# DESIGN-BUILD POST CONSTRUCTION REVIEW

## I-3807 Final Report

**Location:** SR 1128 (Ruin Creek Rd.) widening from just south of I-85 at SR 1218 (Graham Ave.) to north of the US 158 Bypass, approximately 1.04 miles

South end of the project showing the confusing transition from the multilane section to the two lane, two way portion of SR 1128. Future multi-lane alignment will curve to the left on new location.

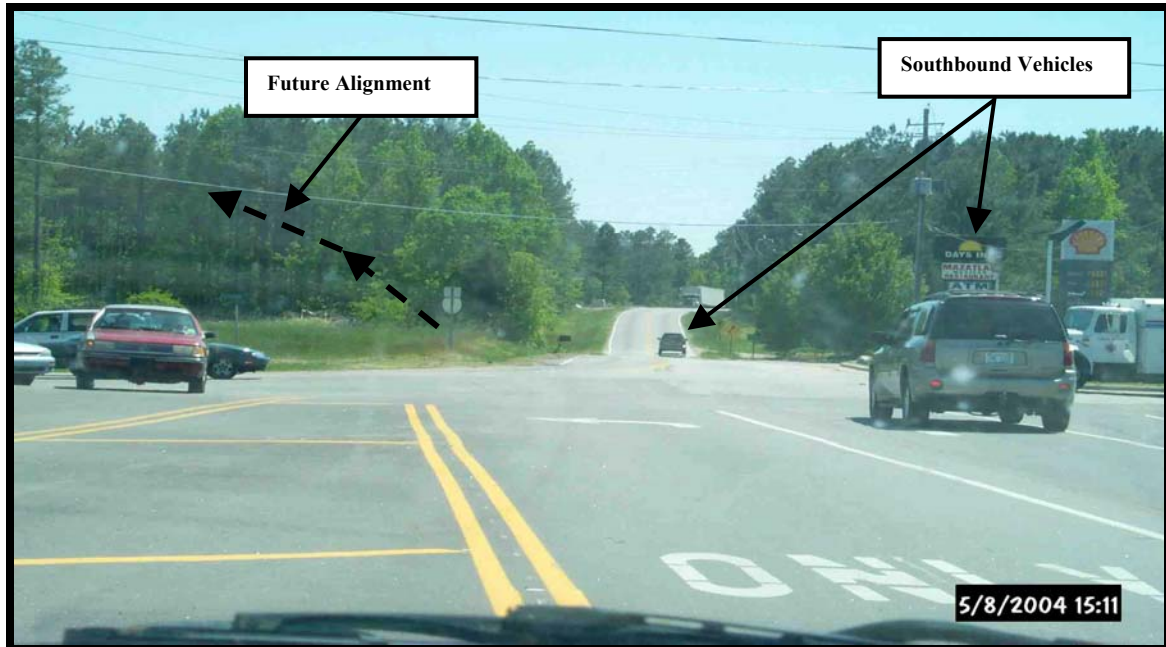
The south end of the project presently is a five lane section (2 through lanes northbound, one through lane and right and left turn lanes southbound) with a wide painted island that continues as a two-lane, two-way facility to the south. The two lane, two way portion of SR 1128 lines up visibly with the south bound lanes of the multilane section. Although this will be corrected when the next section on SR 1128 is constructed, northbound traffic on SR 1128 must abruptly move several lane widths to the right when entering the completed portion of the project. The RFC Plans show this lane configuration; however, the painted island is shown tapering to a 0.6-meter radius nose. The design and lane layout appears similar to that shown on the public hearing map provided to the Design-Build Team. The public hearing map did not show a transition from the five-lane to the existing two-lane facility. The Design-Build Team indicated they did not have enough information about the adjoining project to provide the design they preferred. This area was flagged by NCDOT during the review process and the recommendation was made to add an island and widen the road so northbound traffic shift through the intersection would be less abrupt. The D-B team did not choose to add an island. It should also be noted it is the Design-Build Team's responsibility

to bring to the attention of the Department any design concerns not addressed in the RFP. The following photograph shows the extent of the problem.

It is recommended traffic operation in this area be observed and additional markings or delineation be provided if necessary until the intersection is revised by the adjoining project.
